STAFF REPORT
COMMUNITY DEVELOPMENT DEPARTMENT

HEARING DATE: November 3, 2022
 TO: Planning & Zoning Commission
 FROM: Sonya Allen, Associate Planner
 208-884-5533
 SUBJECT: H-2022-0056
 McDermott Village – AZ, CUP, PP
 LOCATION: 3235 N. McDermott Rd. at the northwest corner of W. Ustick Rd. & N. McDermott Rd., in the SE 1/4 of Section 32, T.4N., R.1W. (Parcel #S0432429360 & #S0432429355)

B. Conceptual Development Plan, Overall Development Plan in the Vicinity & Concept Data

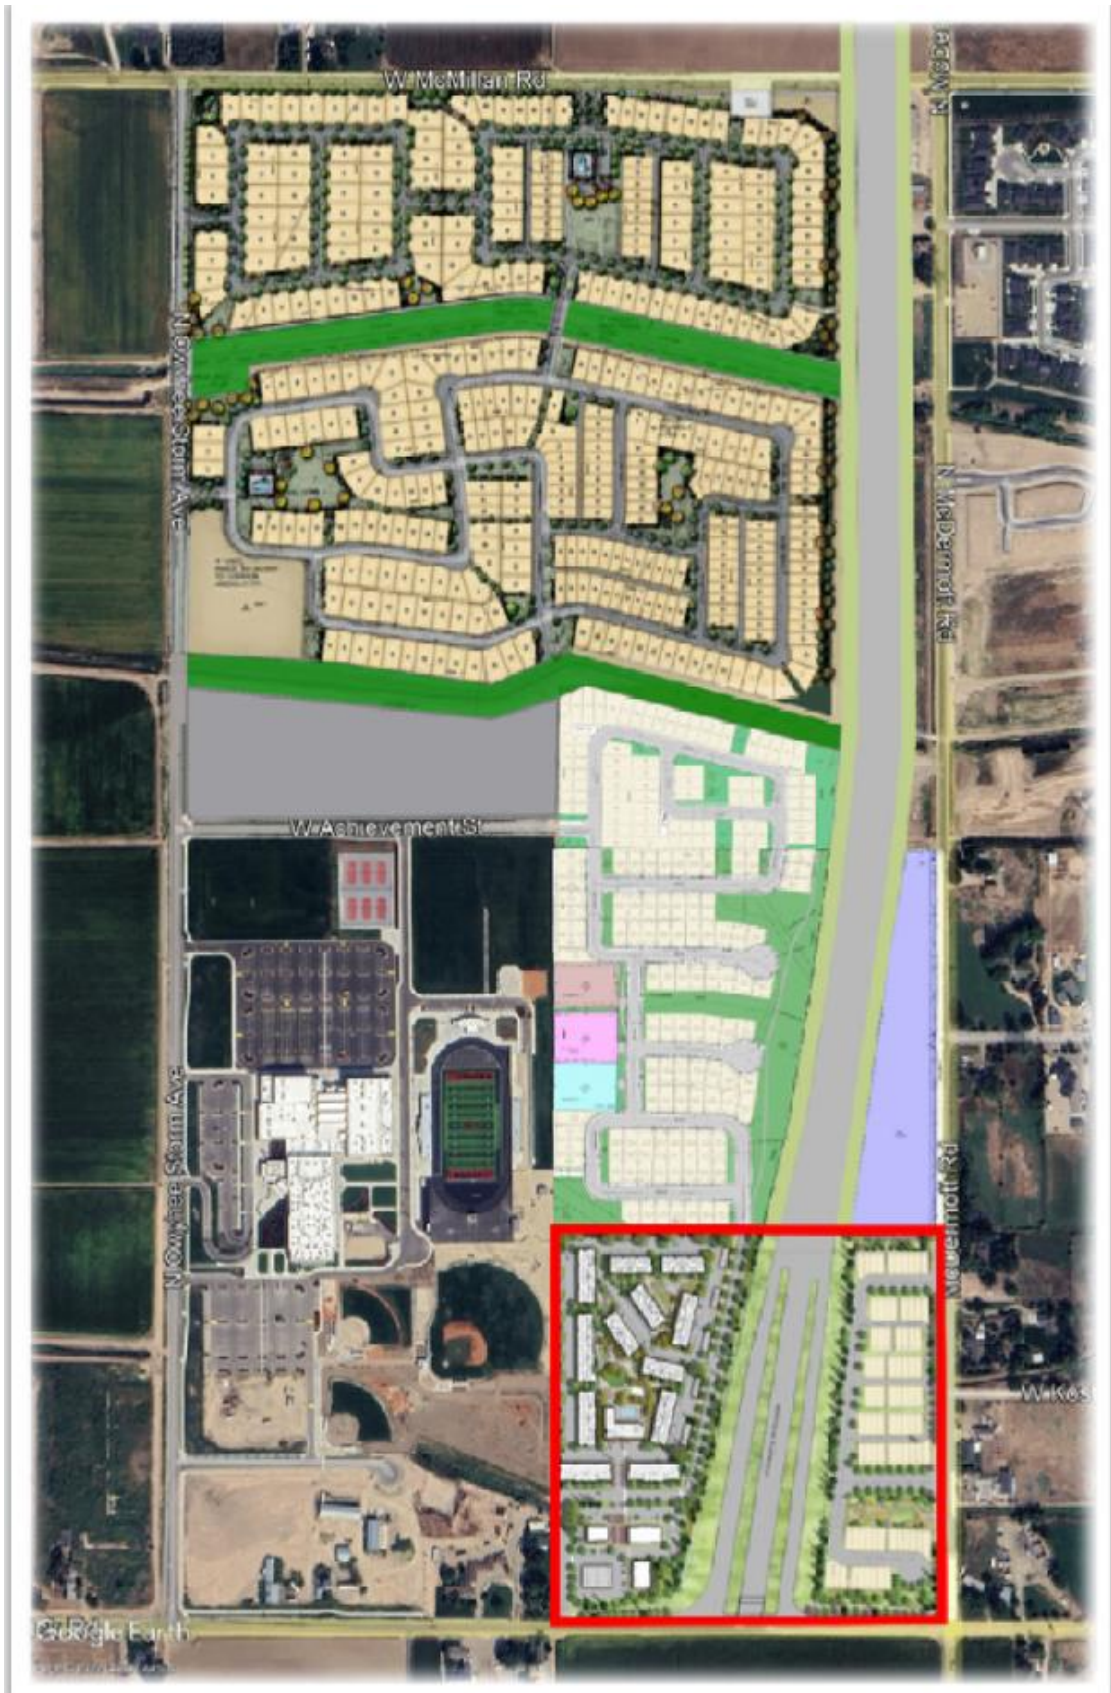
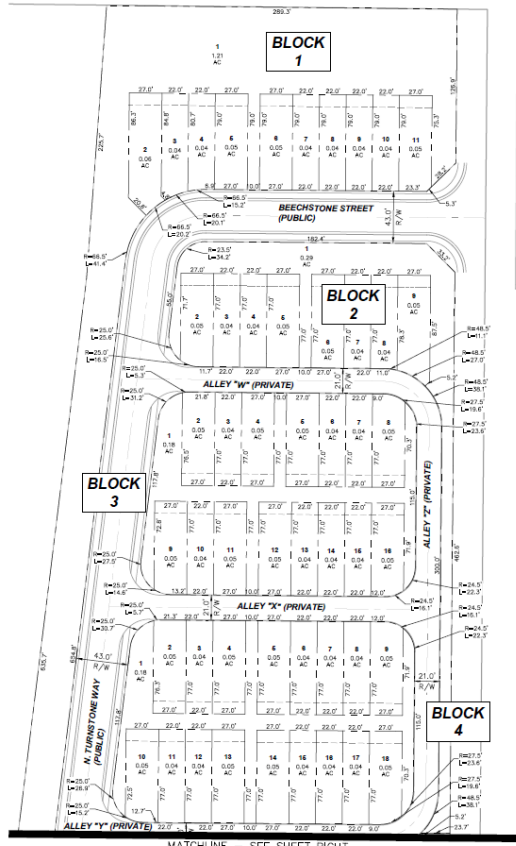
The conceptual development plan depicts a common plaza area between the northern two commercial buildings with a pedestrian walkway to the area from the southern lot (fuel facility/convenience store).

A plaza/gathering area is depicted on the conceptual development plan between the two northern commercial buildings; there are no other public and/or quasi-public spaces or places proposed. As noted above, a high school exists to the northwest and an LDS seminary and a Boys & Girls Club are planned to develop in the Aviator Springs development directly to the north.

No such spaces are proposed on the conceptual development plan. Although a “mix” of uses (i.e. commercial & residential) are proposed, Staff wouldn’t consider this a true mixed-use development due to the lack of integration and connectivity within the overall site, which isn’t possible due to the extension of SH-16 through the property. A plaza/common open space area is depicted between the two (2) northern commercial buildings, which Staff feels is appropriate given the development limitations for this site.

- b. The two (2) commercial buildings proposed on the northern portion of the site shall be arranged to create some form of common, usable gathering area, such as a plaza or green space as depicted on the conceptual development plan in accord with the mixed-use guidelines in the [Comprehensive Plan](#) (see pg. 3-13).

1 LANDSCAPE PLAN - OPEN SPACE DIAGRAM - R40
 PRELIMINARY PLAT OPEN SPACE, AMENITY, &
 STREET TREE CALCULATIONS - R40
 SCALE: 1" = 40'-0" @ 24536
 McDermott and Ustick, MERIDIAN, ID
 2022014.01

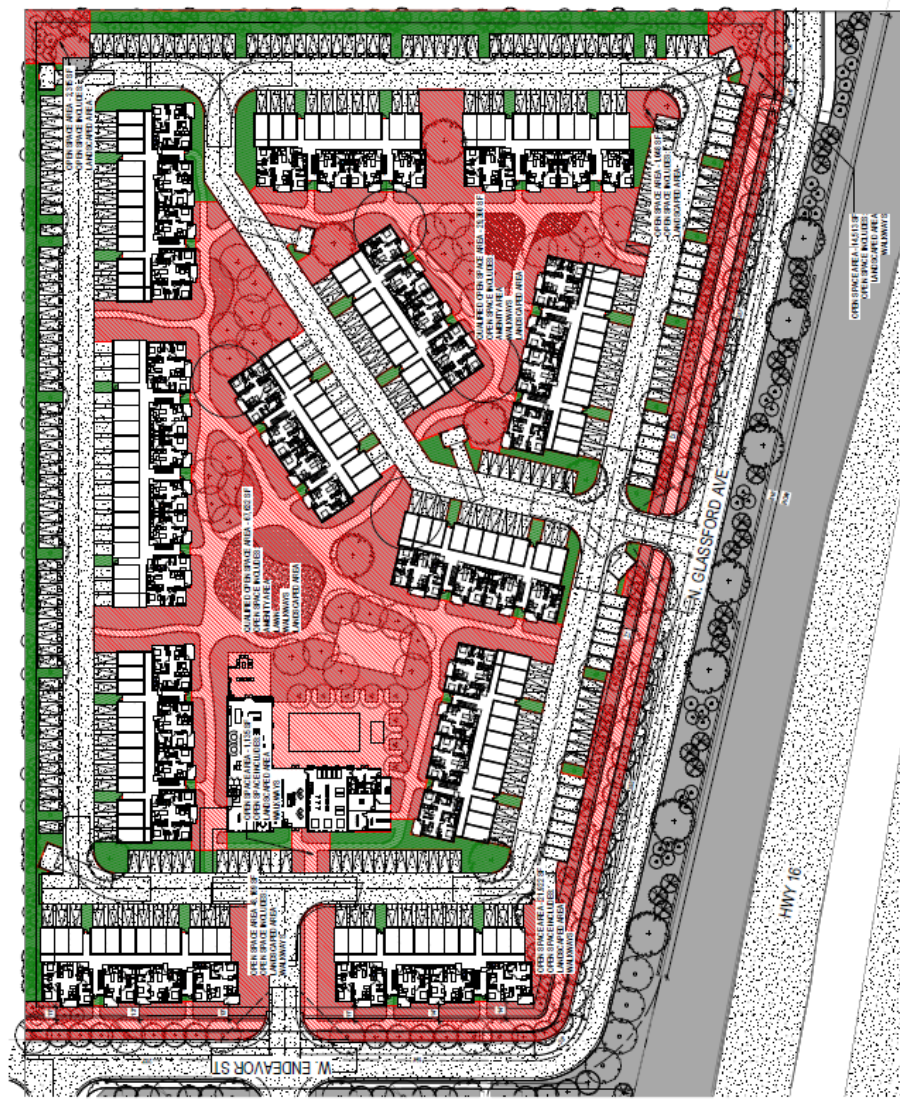
At a minimum, a total of 66,400 s.f. (or 1.52 acres) of qualified outdoor common open space is required to be provided per this standard. In order to meet the baseline requirement noted above and this standard, a total of 119,500 s.f. (or 2.74 acres) of common open space is required. A total of 146,094 s.f. (or 3.35 acres) of qualified open space is proposed in excess of the minimum standards as shown in Section VII.F (red hatch areas). Qualified areas consist of central common/amenity areas and a pedestrian corridor where a multi-use pathway is planned.

3. The landscape plan submitted with the final plat shall be revised as follows:
 - a. Depict the bollards proposed to restrict access to the emergency access driveway off W. Ustick Rd. completely outside of the right-of-way.

- b. Depict a 10-foot wide multi-use pathway within the street buffers along SH-16 within a 14-foot wide public use easement; the easement shall be submitted to the Planning division prior to submittal of the final plat for City Engineer signature.

- e. Depict landscaping within common open space areas as set forth in UDC 11-3G-5B.3.
 - f. Change the Fraxinus Pennsylvanica "Marshall's Seedless" Green Ash tree to another variety per the City Arborists' comments.

1 LANDSCAPE PLAN - OPEN SPACE DIAGRAM - R15
 PRELIMINARY PLAT OPEN SPACE, AMENITY, &
 STREET TREE CALCULATIONS - R15
 SCALE: 1" = 40'-0" @ 24036
 L-004
 06/30/2022
GGLO pivot north
 ARCHITECTURE
 McDermott and Ustick, MERIDIAN, ID
 2022014.01

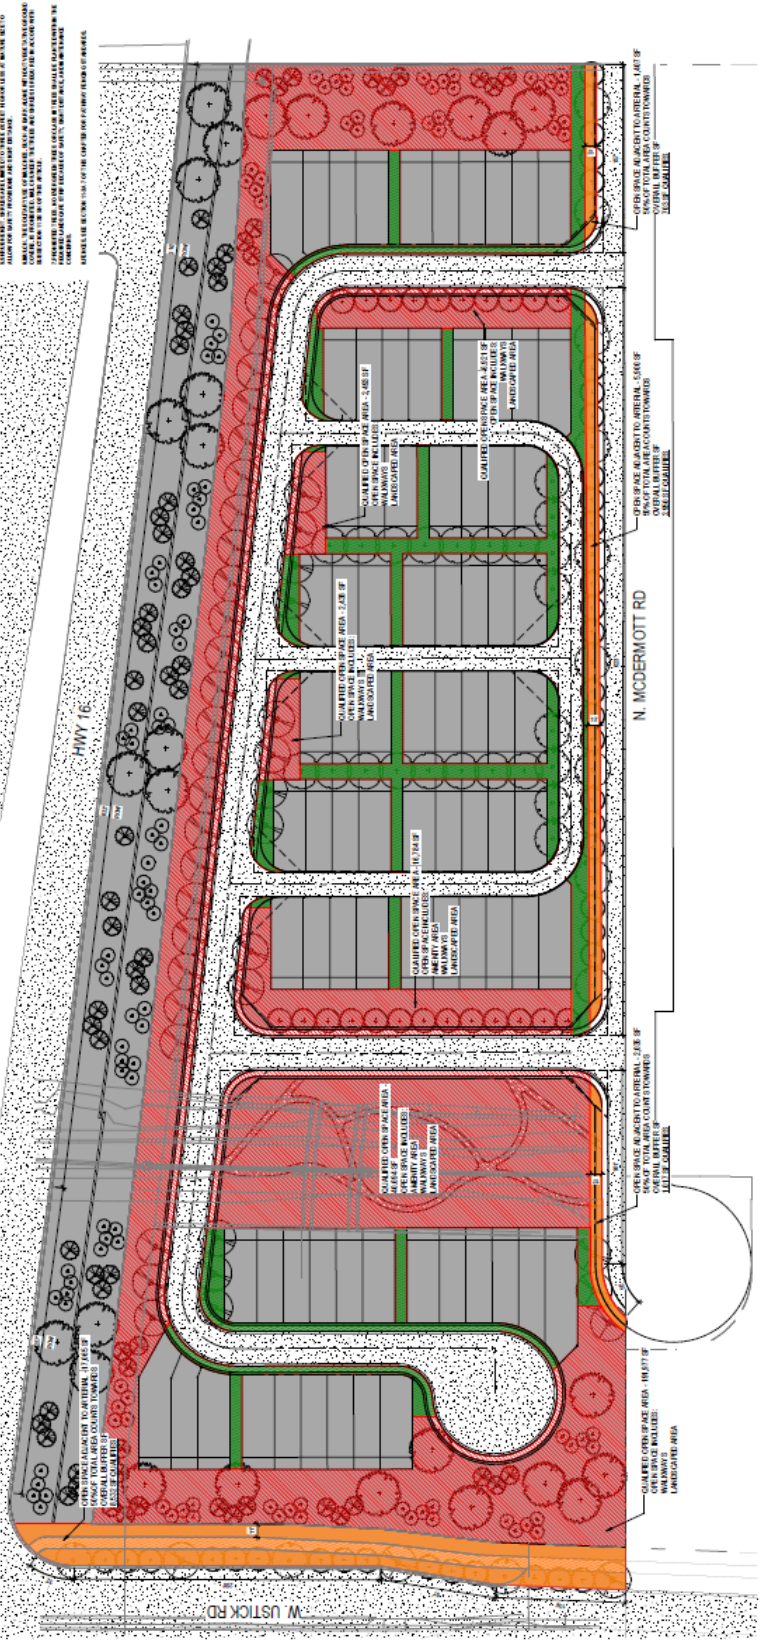
Site Amenities (UDC [11-3G-4](#)): A minimum of 2 points of site amenities are required based on 10.51 acres of development area from the Site Amenities and Point Value [Table 11-3G-4](#). It’s not clear to Staff what is proposed for site amenities in the townhome portion of the development. The Applicant should clarify prior to or at the Commission hearing what amenities are proposed.

- g. Depict a minimum of two (2) points of site amenities for the townhome portion of the development from the Site Amenities and Point Value [Table 11-3G-4](#). **The Applicant should clarify prior to or at the Commission hearing what amenities are proposed.**
